CITY OF SEASIDE
BOARD OF ARCHITECTURAL REVIEW

REGULAR MEETING
COUNCIL CHAMBER
440 Harcourt Avenue
Wednesday, April 4, 2018
5:30 PM

- A. BOARD OF ARCHITECTURAL REVIEW APPLICATION NO. BAR -17-15. ARTHUR NOBIDA, PROPERTY OWNER AND APPLICANT, IS REQUESTING DESIGN REVIEW APPROVAL FOR A SECOND STORY ADDITION TO AN EXISTING ONE-STORY SINGLE FAMILY RESIDENCE LOCATED AT 1739 YOSEMITE STREET IN THE SINGLE FAMILY RESIDENCE LOCATED AT 1739 YOSEMITE STREET IN THE SINGLE FAMILY RESIDENTIAL (RS-8) ZONING DISTRICT (APN 012-101-065). THIS PROJECT IS CATEGORICALLY EXEMPT CLASS 1, SECTION 15301.EA, EXISTING FACILITIES, FROM THE CALIFORNIA ENVIRONMENTAL QUALITY ACT. THIS ITEM WAS CONTINUED FROM THE FEBRUARY 21, 2018 BOARD OF ARCHITECTURAL REVIEW MEETING.**

ADDITION AND REMODEL TO :
NOBIDA RESIDENCE
1739 YOSEMITE STREET , SEASIDE CA

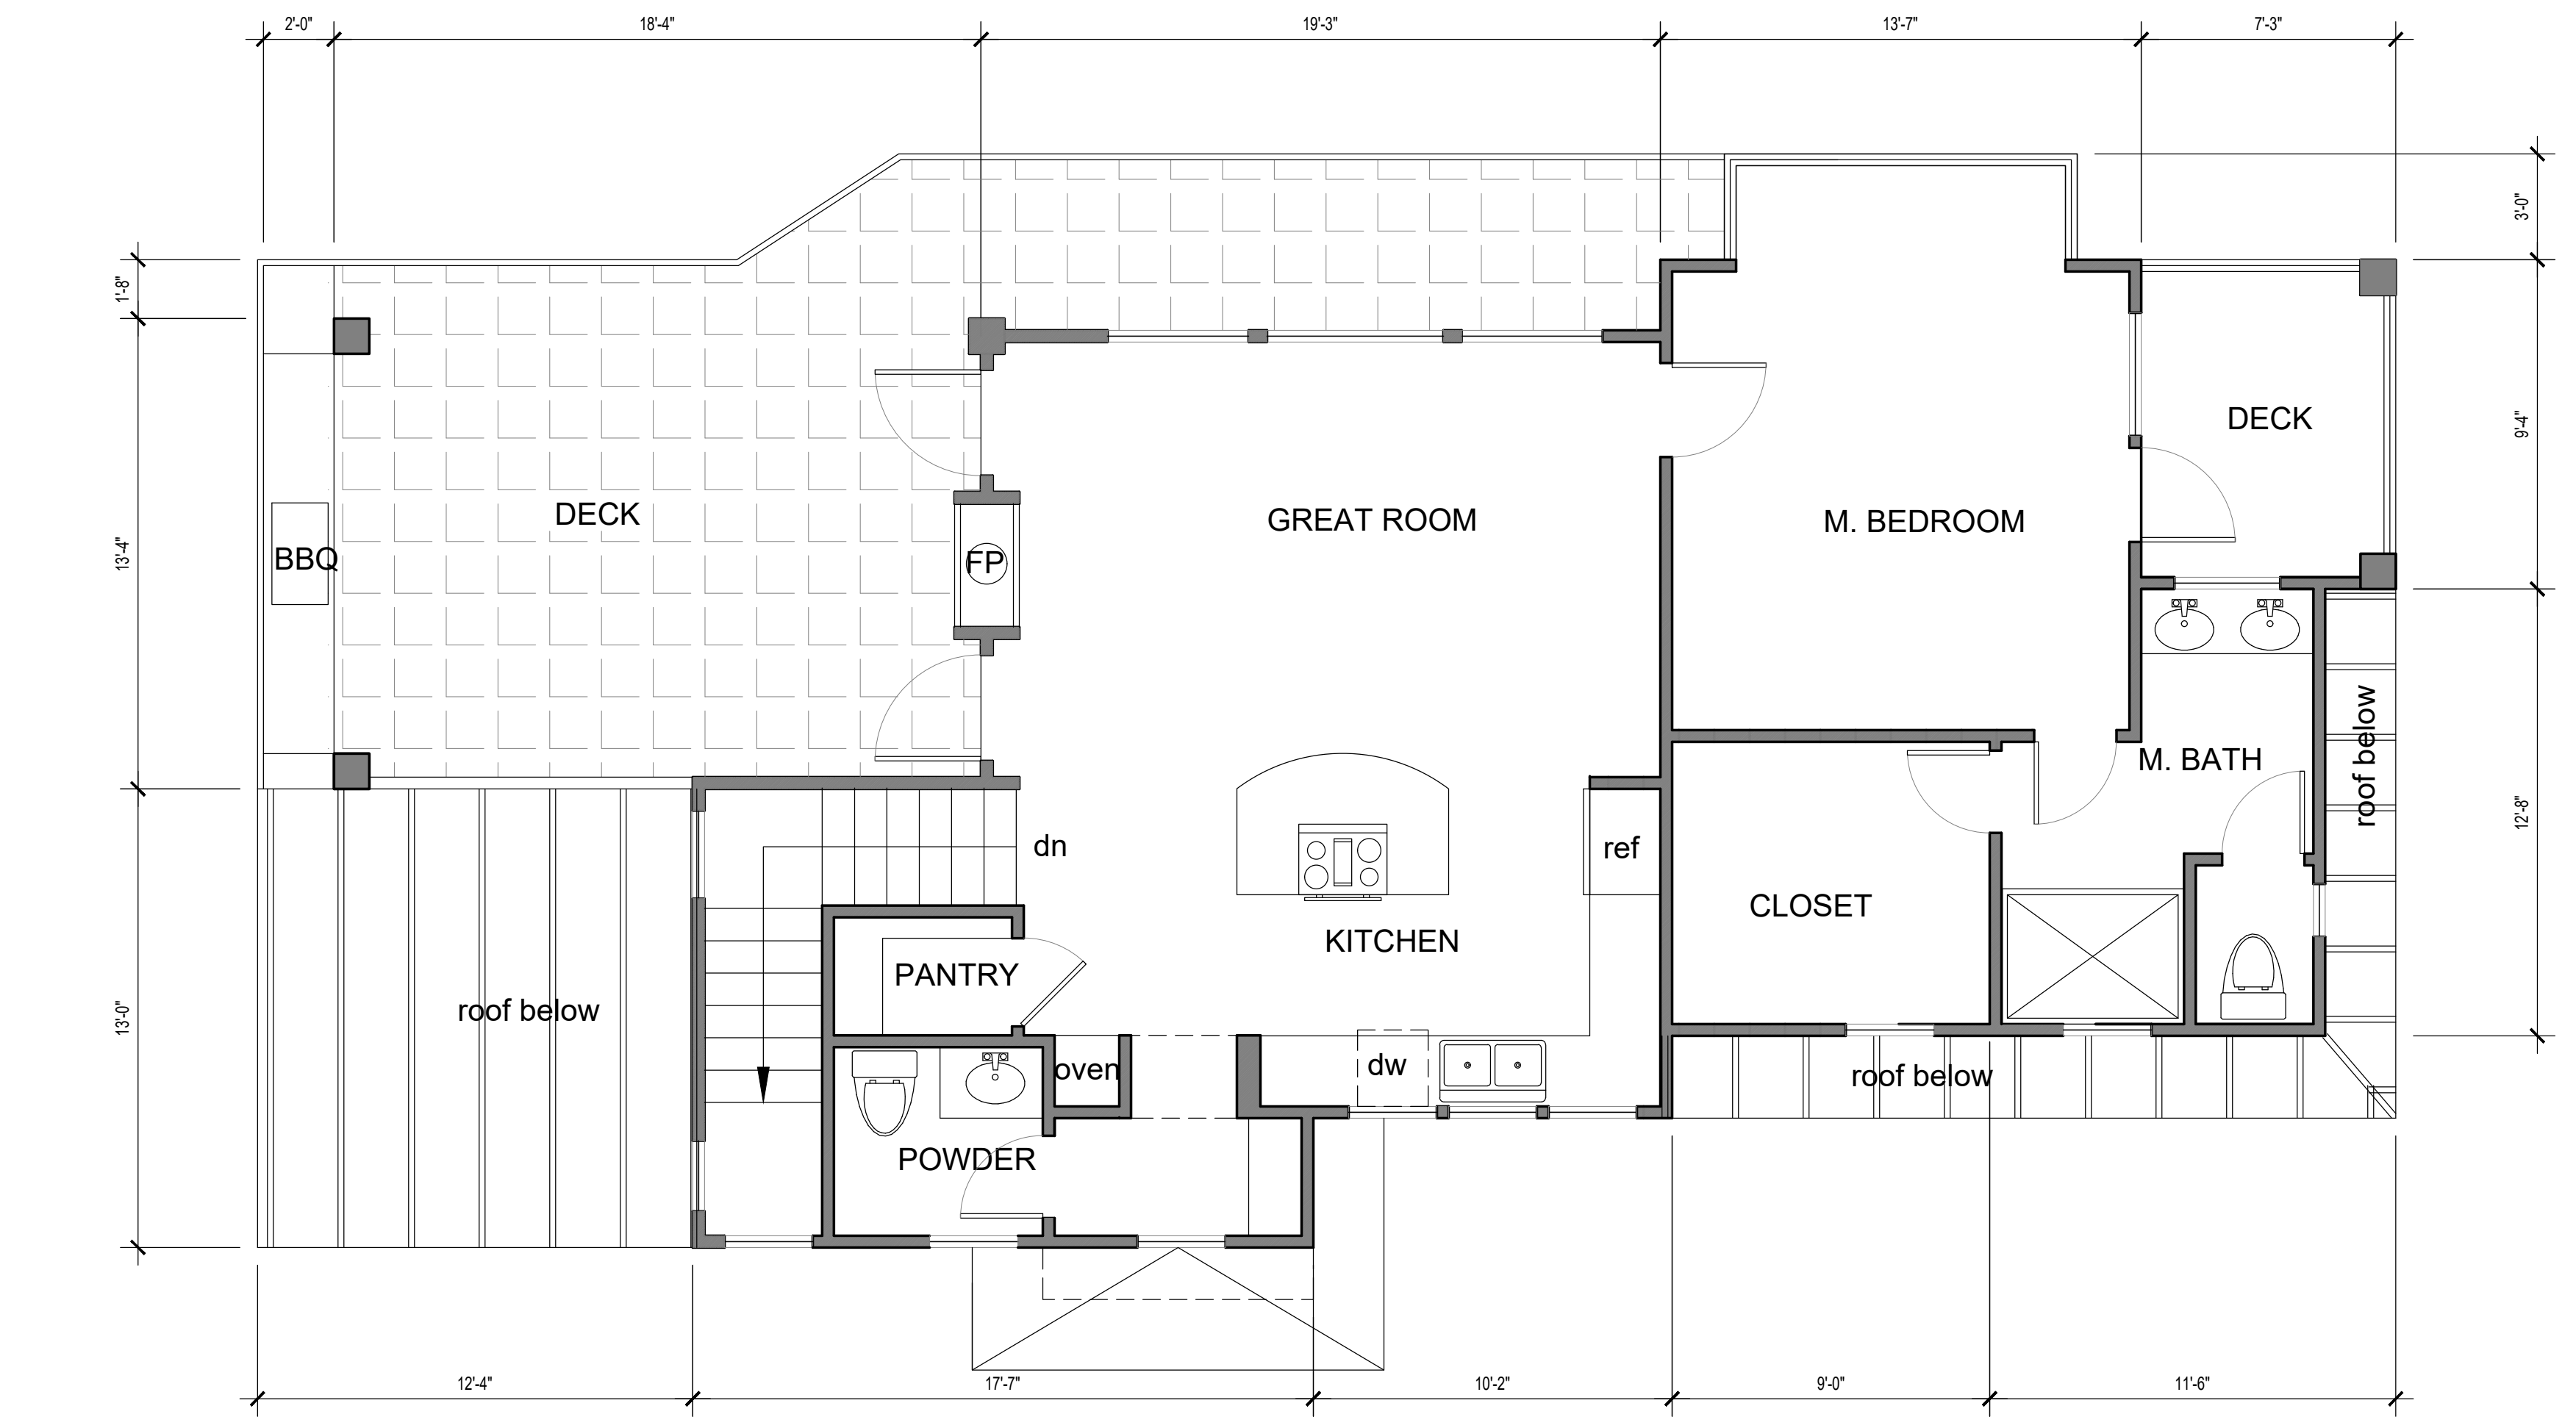
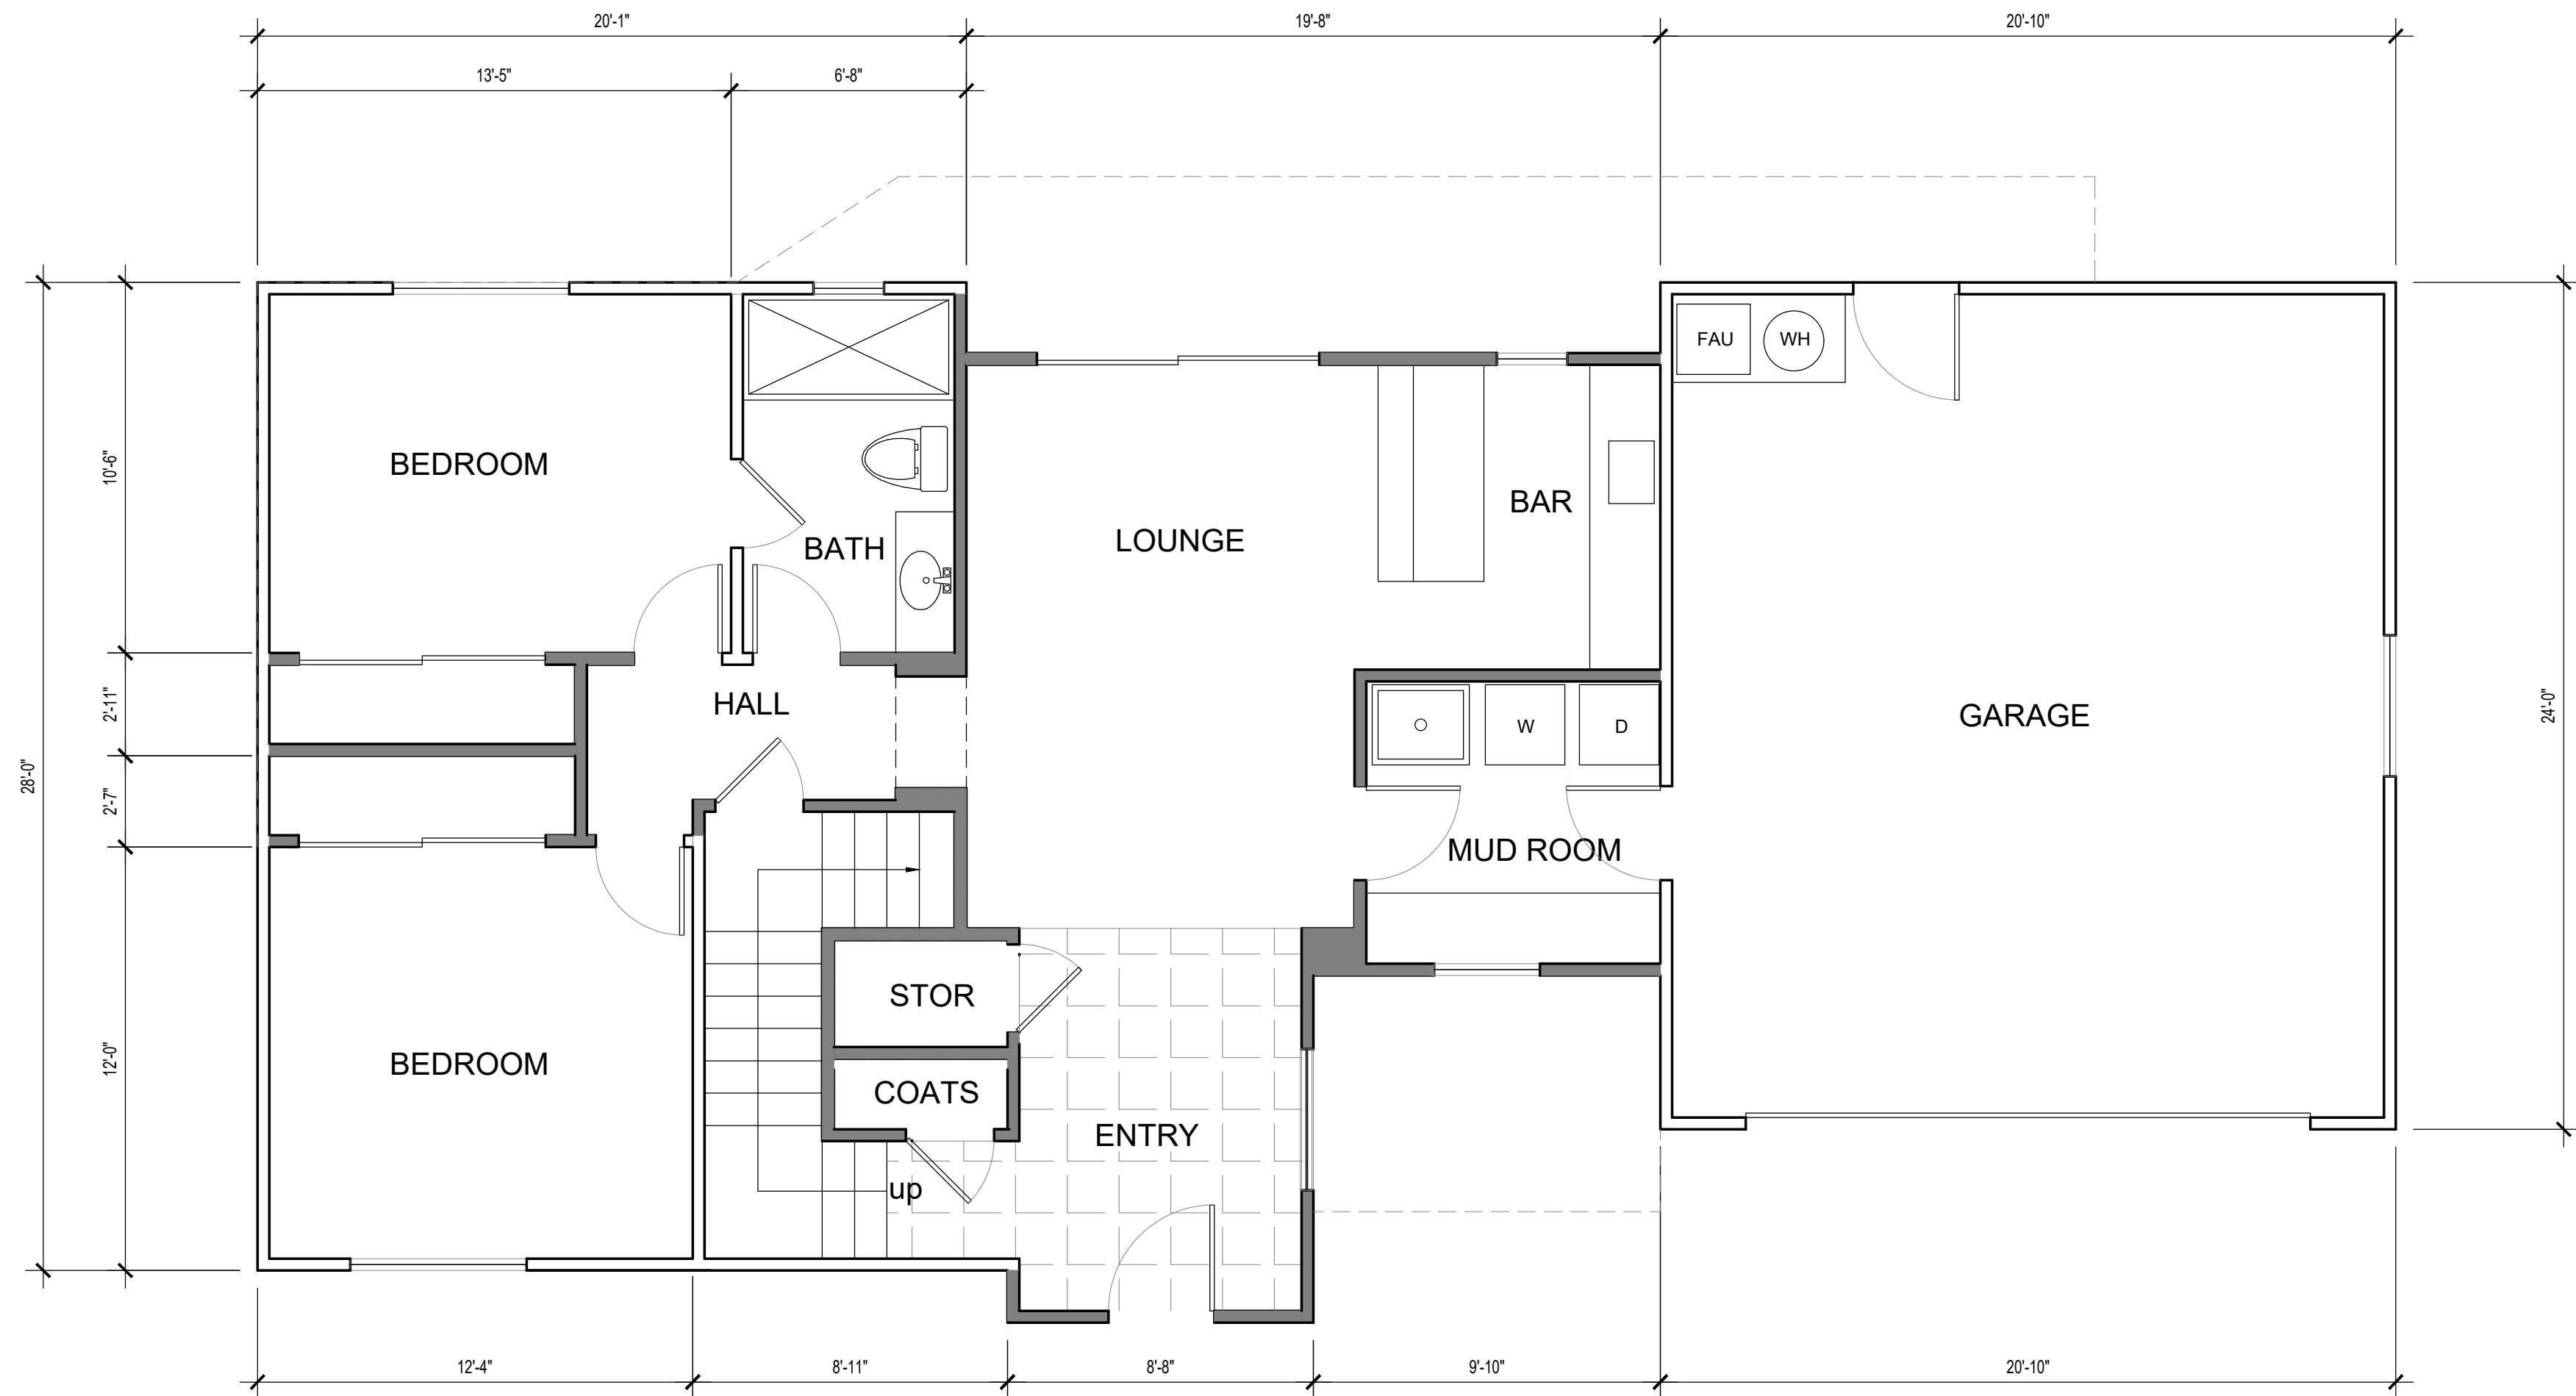
- Consider lowering the 9 foot plate height of the second story.
- Consider modifying the architectural design of the second story element to provide setbacks from the first story.
- Cut back the roof that extends over the second story deck off of the Great Room.
- Review enlarging the front entrance and match this roof to the rest of the house.

The BAR had concerns with the amount roof area being added, substantial second story building offsets from the first floor footprint and the lack of a cohesive entry feature over the front door. The BAR must evaluate the changes to determine if the design modifications made to the proposed project will provide a design which not only meets the minimum design standards but will also provide a cohesive design to blend with the neighborhood.

- 1) Lowered ridge line of roof from 23'5" to 22'6"
- 2) Created flat sections of roof
- 3) Plate height Lowered from 9' to 8'
- 4) Downsized roof width 2' on north and 2' on south side for a total of 4'
- 5) Provided set back of north/east side of 2' over garage
- 6) Shortened height of master bedroom bay window and now frameless
- 7) Front door added hip to match house roof
- 8) Plant 5 Queen Palm trees across backyard property line for neighbors' privacy

- 9) Downsized deck off master bedroom and all wood siding for railing
- 10) Downsized master bedroom and master bathroom shower
- 11) Added window in bathroom facing west
- 12) Added bbq area on south side of deck
- 13) Wood siding for south side of deck
- 14) Changed to vinyl casement windows
- 15) Added wood siding to west side center and larger window at bar
